RN SERIES TECHNICAL BULLETIN

ISSUE NO. : RNT-003

SUBJECT: 021-18202-204 Cutter Sheet

Brief:
The Cutter Sheet is redesigned for smooth master feeding.

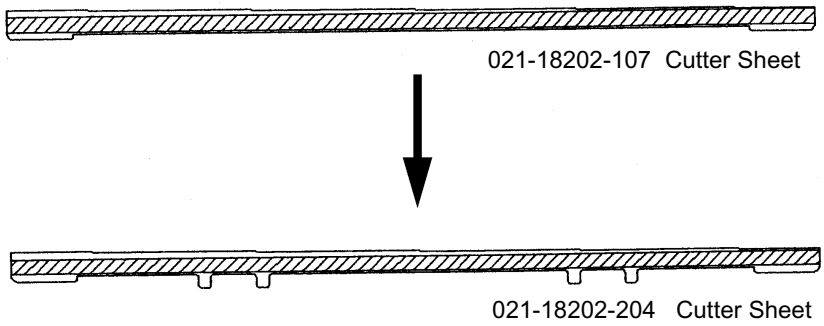
Reason:
The previous Cutter Sheet tends to obstruct master feeding, expecially when the leading edge of the master is strongly curled. The leading edge of the master, during the master setting operation, cannot reach the Master Positioning Sensor, and master feed error "A01-201" appears.

Newly-registered Part
021-18202-204 Cutter Sheet
